ADDENDUM #3
KEARNEY REGIONAL AIRPORT
NEW HANGAR
KEARNEY, NEBRASKA
1238

Wilkins Hinrichs Stober Architects, L.L.C.
2908 West 39th Street, Suite A
Kearney, Nebraska 68845
308-237-5787

Date Issued: March 28, 2013
Bid Date: April 2, 2013
Revised Bid Date: April 9, 2013

2
A-1

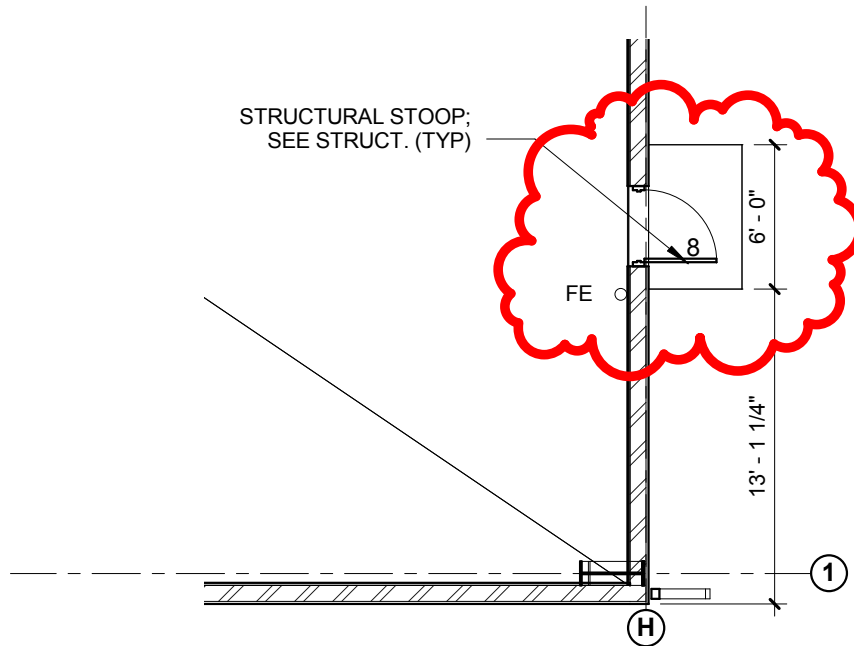
- Addendum #3 - #9 SHEET A1.0 – FLOOR PLAN – GROUND FLOOR**
1/A1.0 FLOOR PLAN – GROUND FLOOR: Add new door and structural stoop to West Elevation on North-West corner of building, Door No. 10 as shown on attachment 2/A1 to Addendum No. 3 dated March 28, 2013.

1
A-1

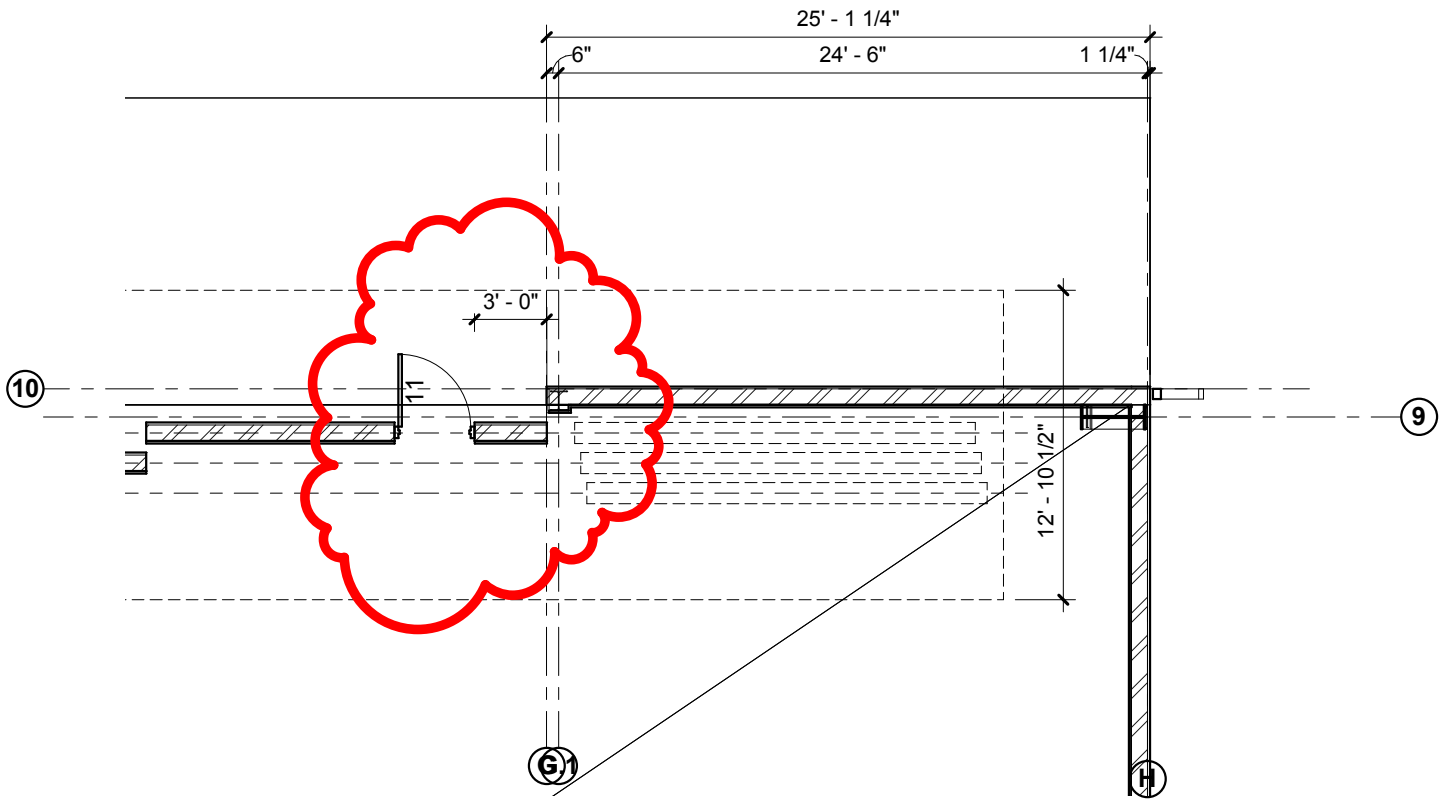
- Addendum #3 - #8 SHEET A1.0 – FLOOR PLAN – GROUND FLOOR**
1/A1.0 FLOOR PLAN – GROUND FLOOR: At Door No. 8 on SW corner of building, Change door swing so that the hinge side of the door is to the West as shown on attachment 1/A1 to Addendum No. 3 dated March 28, 2013.

1
A-2

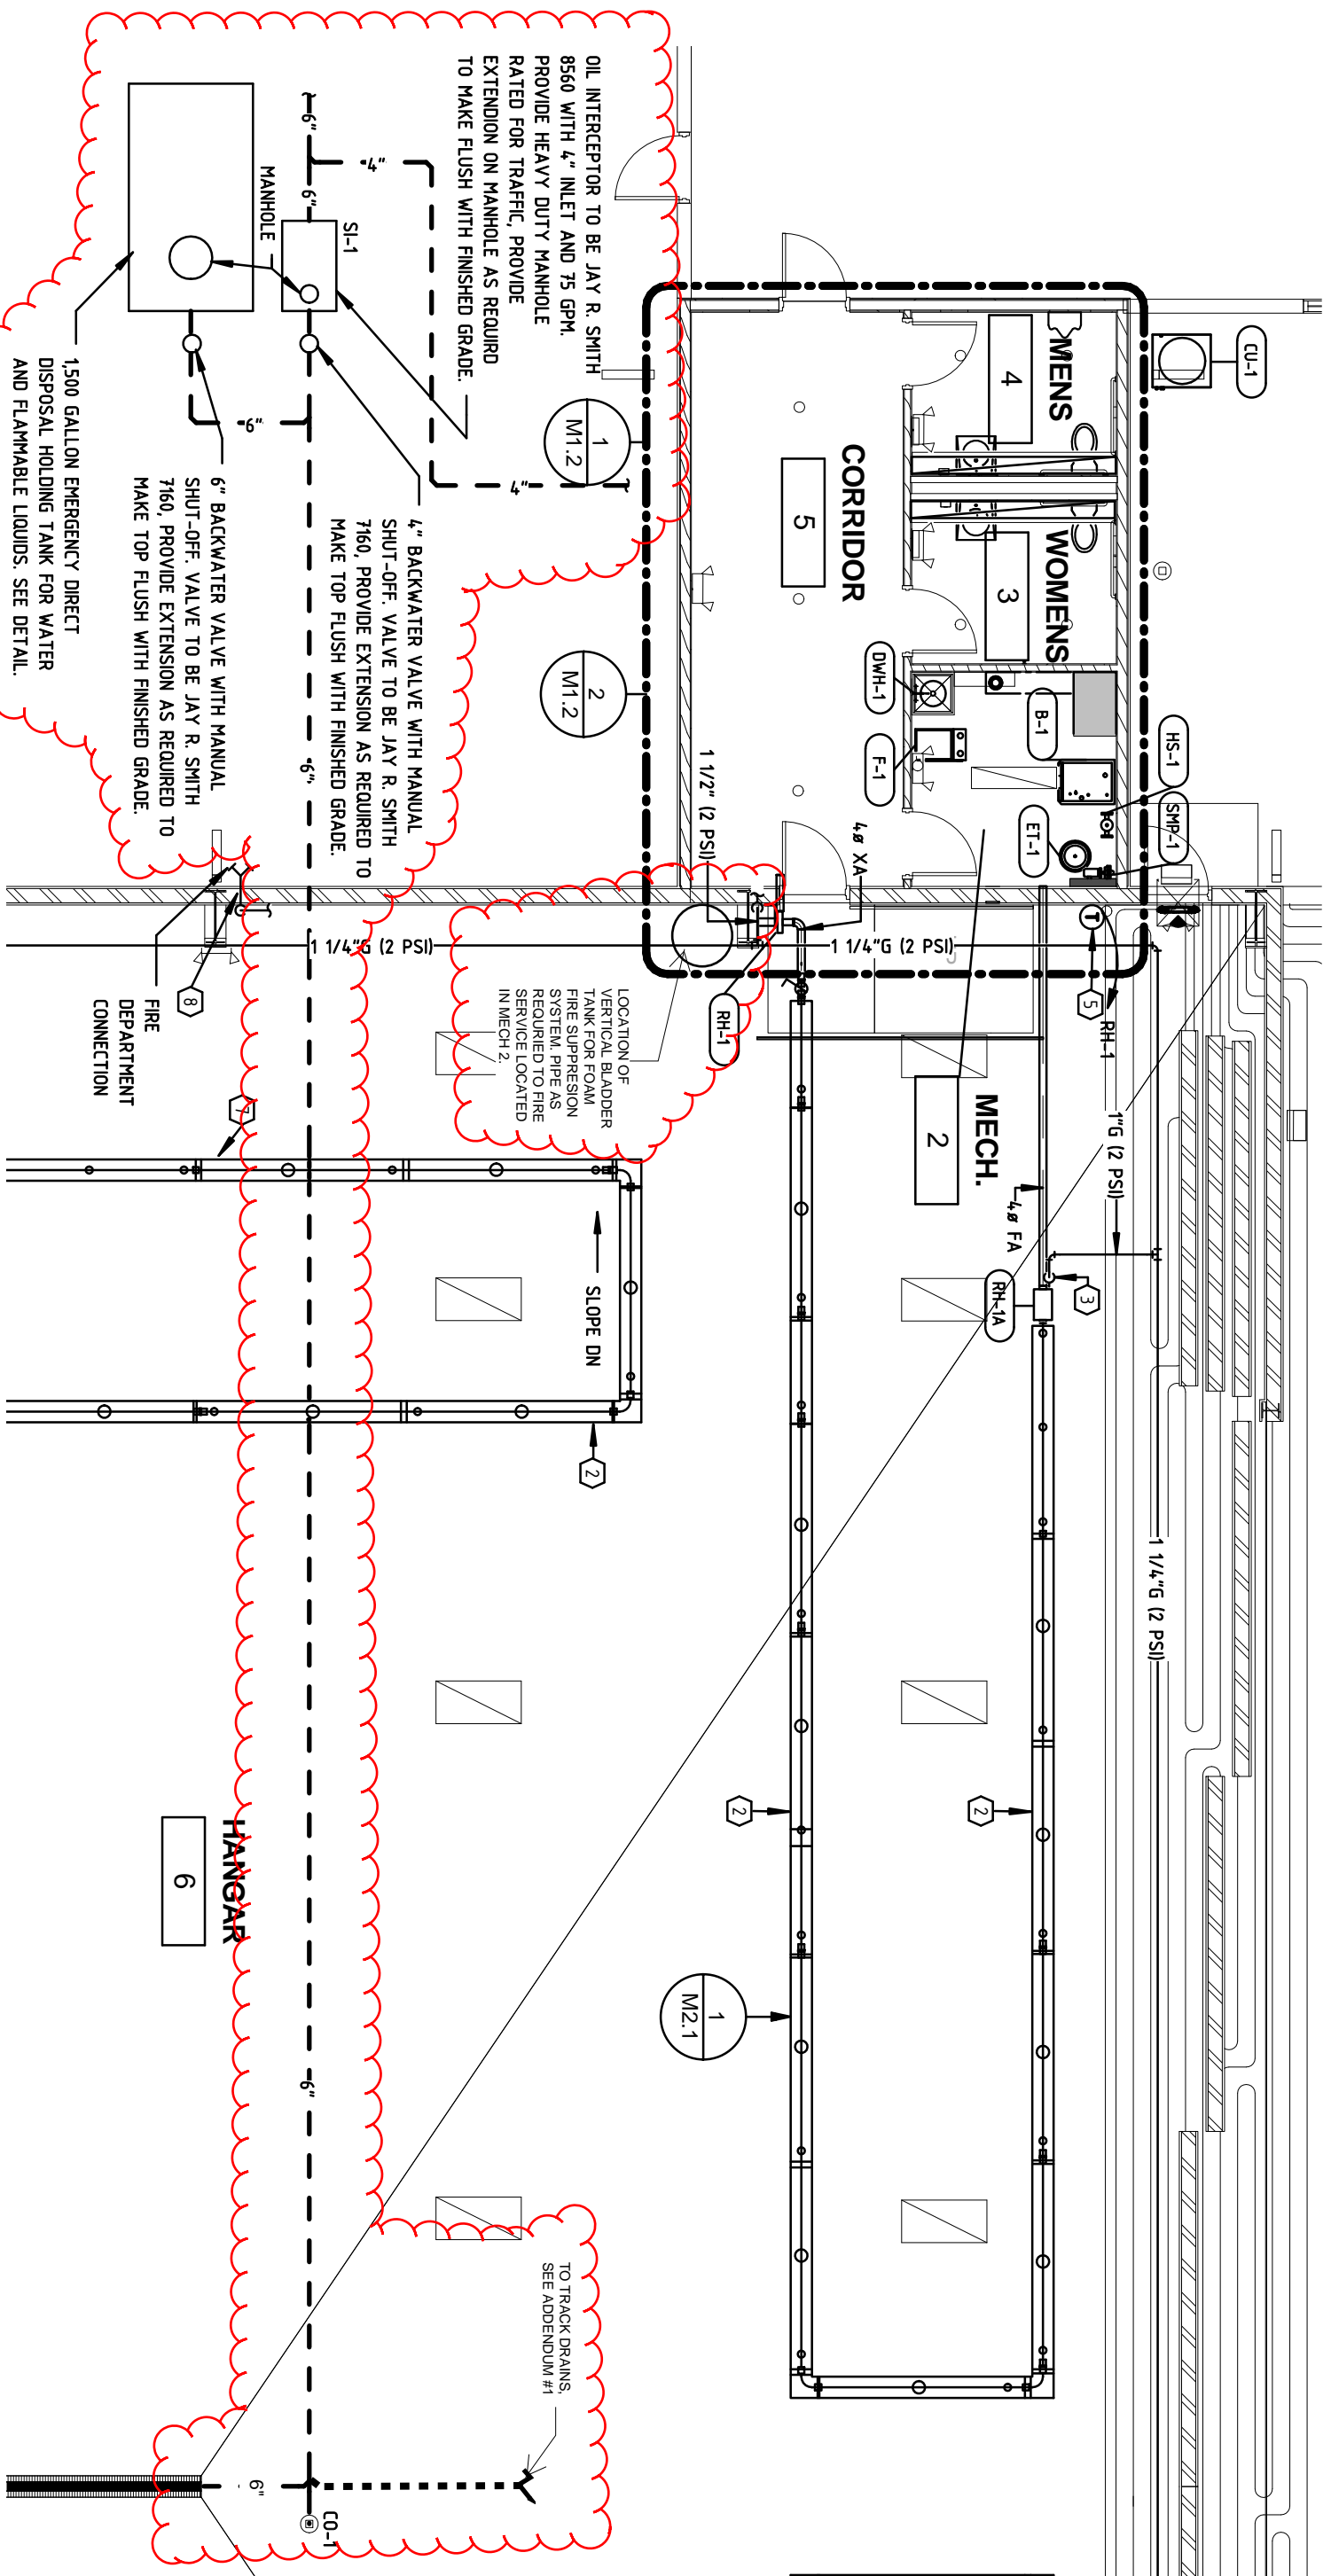
- Addendum #3 - #10 SHEET A1.0 – FLOOR PLAN – GROUND FLOOR**
1/A1.0 FLOOR PLAN – GROUND FLOOR: Add new door to East Elevation on South-East corner of building, Door No. 11 is to be installed in Southern most panel door of the Bi-parting rolling door system as shown on attachment 1/A2 to Addendum No. 3 dated March 28, 2013. Coordinate opening and installation with Bi-parting door manufacturer.

FIRST FLOOR PLAN - MECHANICAL / HVAC

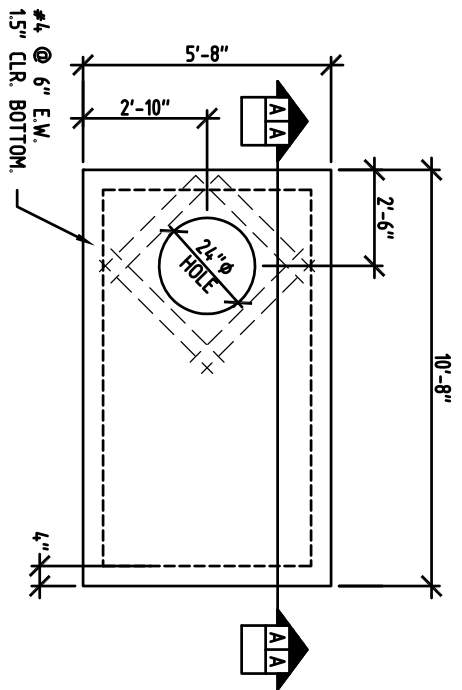
- Addendum #3 - #17 SHEET M1.1 – FIRST FLOOR PLAN – MECHANICAL/HVAC**
The oil separator shall be moved to the exterior of the building and the sanitary sewer shall be connected to the east end of the trench drain in lieu of the middle as originally shown. Per NFPA 409 a manual bypass shall be provided around the oil separator with the bypass line connected to an emergency direct disposal holding tank. See attached supplemental drawings for more details and information.

Sheet Number:
E2.1

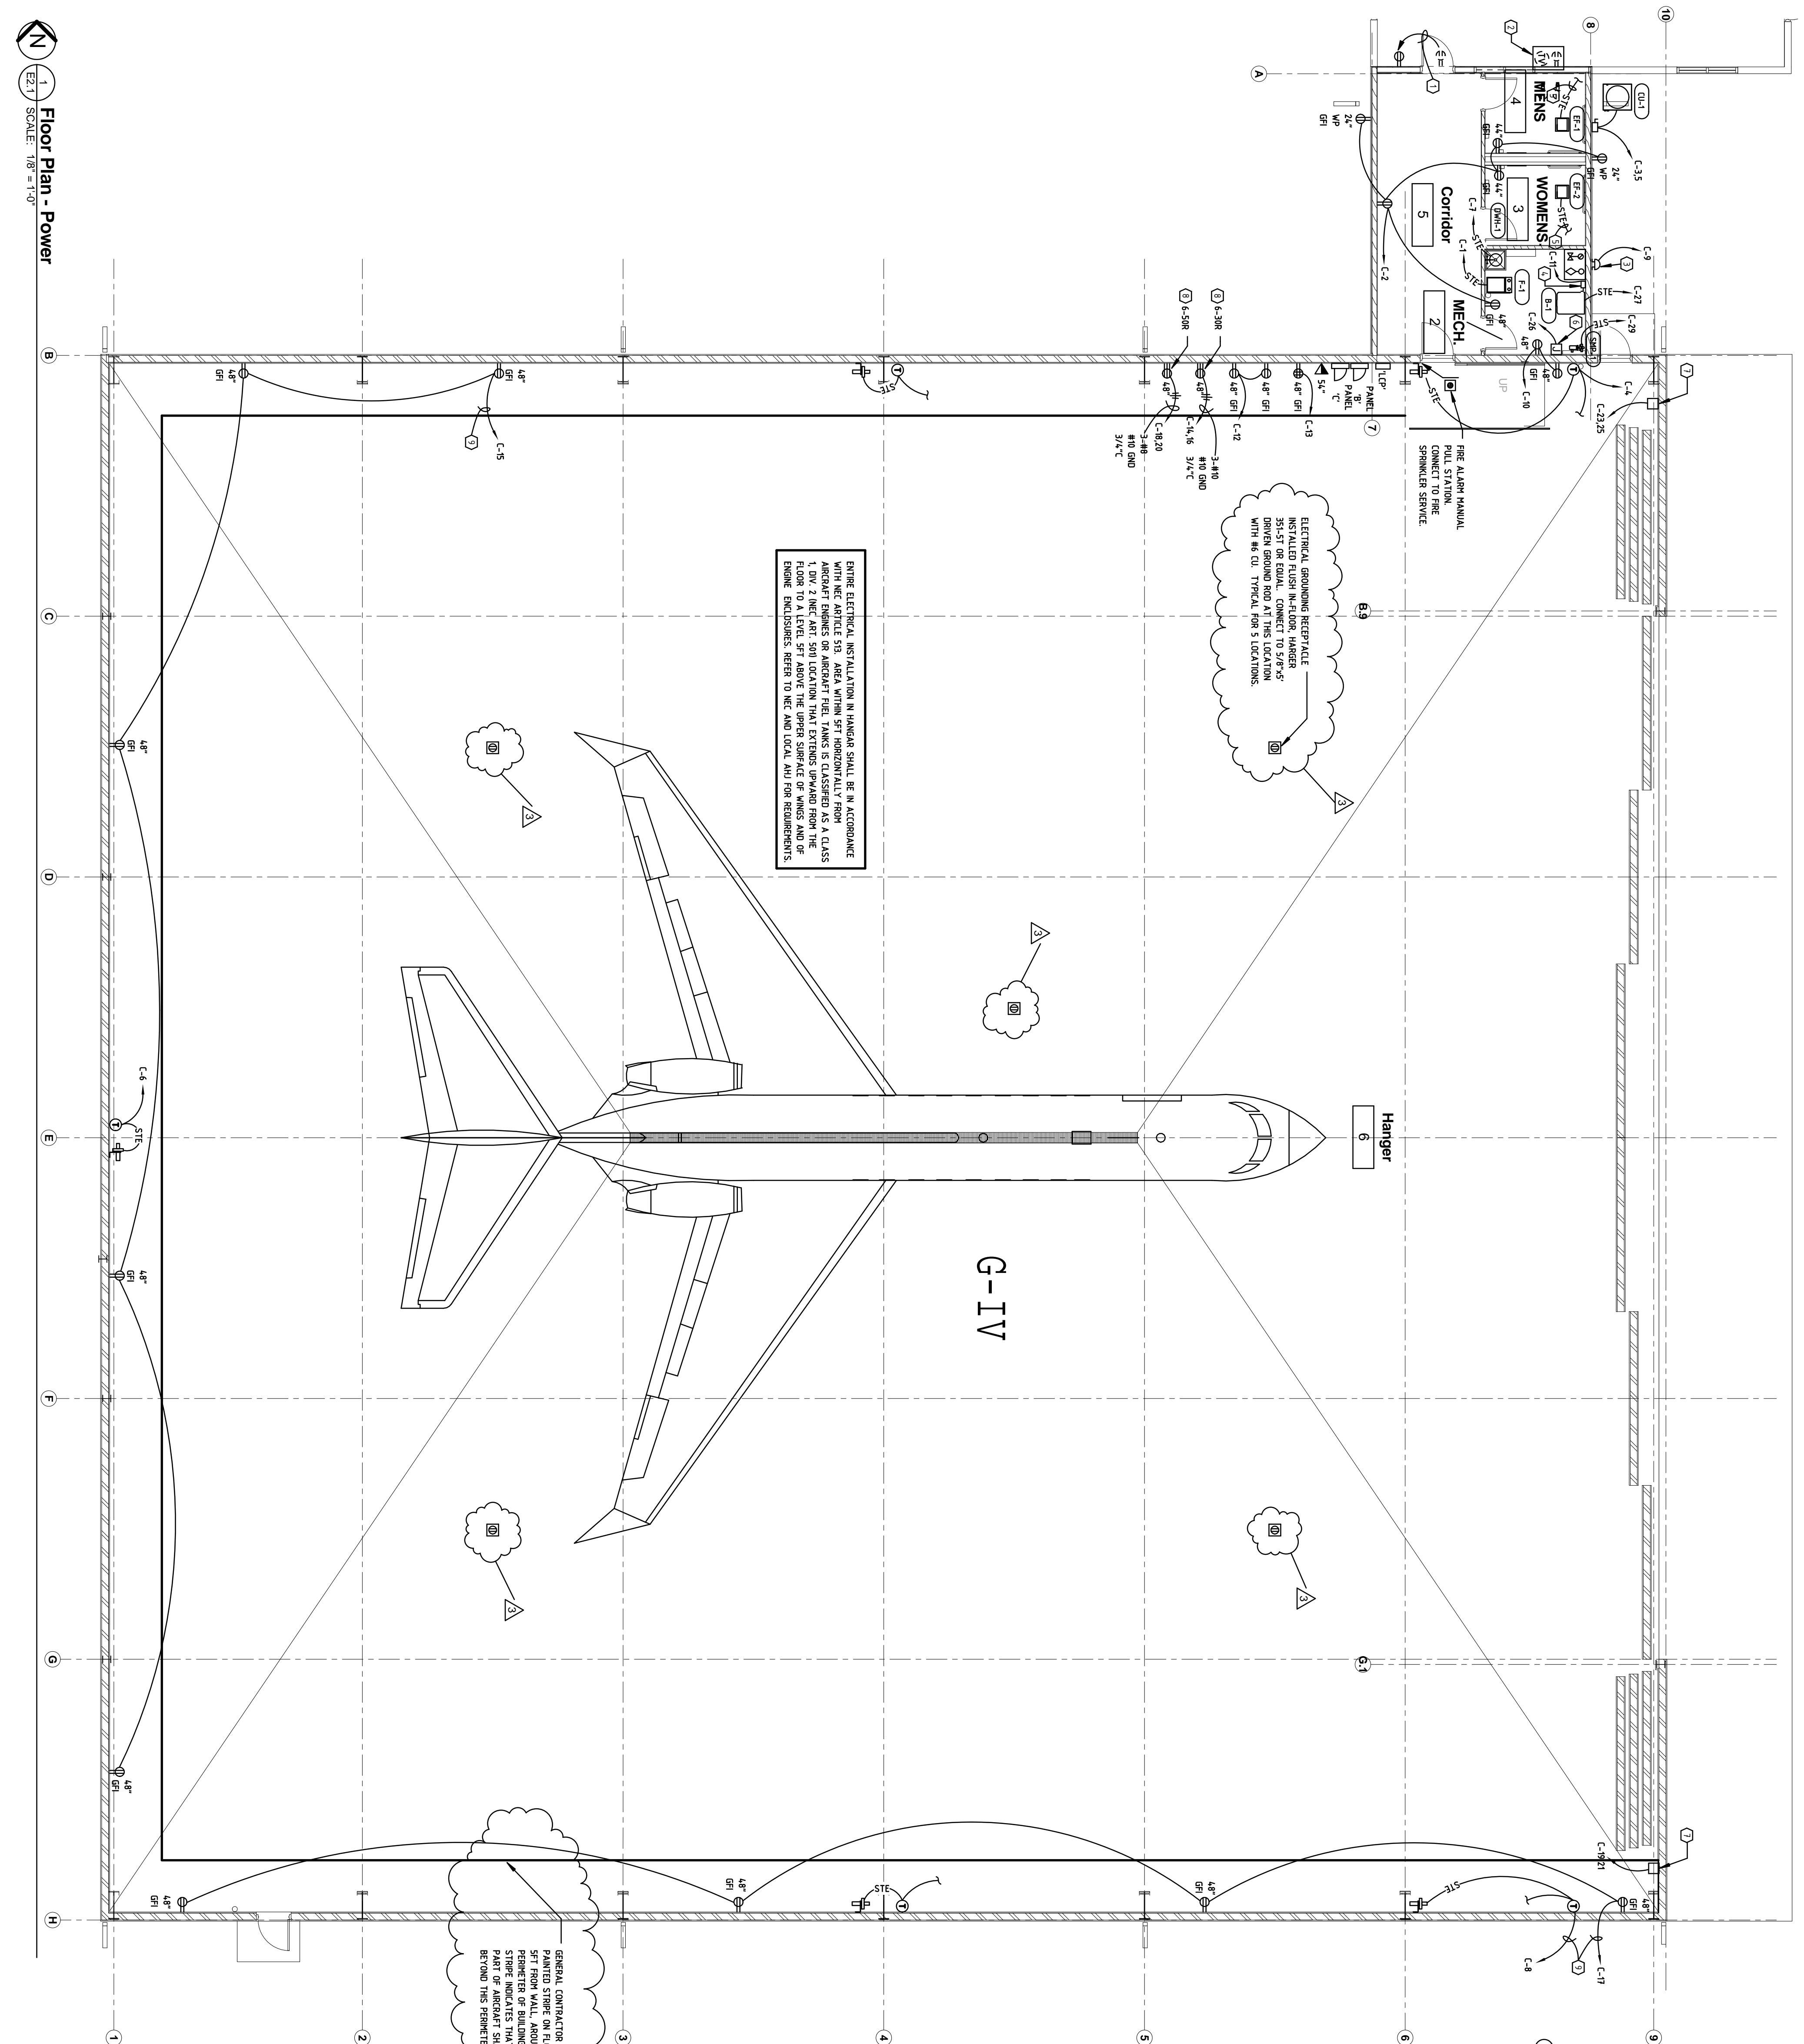
- Oil Separator (SI-1): oil separator to be Jay R. Smith 8560 with 4" inlet with 75 gpm inlet capacity.
- Addendum #3 - #19 SHEET E2.1 – FLOOR PLAN - POWER**
See attached floor plan with revision clouds. Electrical Grounding Receptacle – Set screw connection to ground conductor is acceptable. Provide 5/8" x 5ft driven ground rod at each grounding receptacle location and connect with #6CU. Do not provide a #8CU wire in 3/4" c. to electrical panel ground. Wiring connection to ground receptacle can be placed directly in concrete, install per manufacturer recommendations. (Floor sheet referred to is a large size plan which will be mailed separately)

- Addendum #3 - #20 SHEET E2.1 – FLOOR PLAN - POWER**
Per NEC 500.4 – Provide documentation that indicates all areas designated at hazardous (classified) locations. This documentation shall be available to those authorized to design, install, maintain, or operate electrical equipment at these areas. Documentation shall consist of a laminated floor plan with notes indicating areas designated as classified locations. Classified areas shall be color coded for easy identification. Install at readily accessible location in a framed enclosure.

- Addendum #3 - #21 SHEET E2.1 – FLOOR PLAN - POWER**
Delete Keynote 4 and electrical equipment/connections for dry type sprinkler system.
- Addendum #3 - #22 SHEET E3.1 – ELECTRICAL SCHEDULES**
New Panel B – This is a 125 amp MLO loadcenter and does not have a main breaker. New Panel C - This is a 150 amp MLO loadcenter and does not have a main breaker.
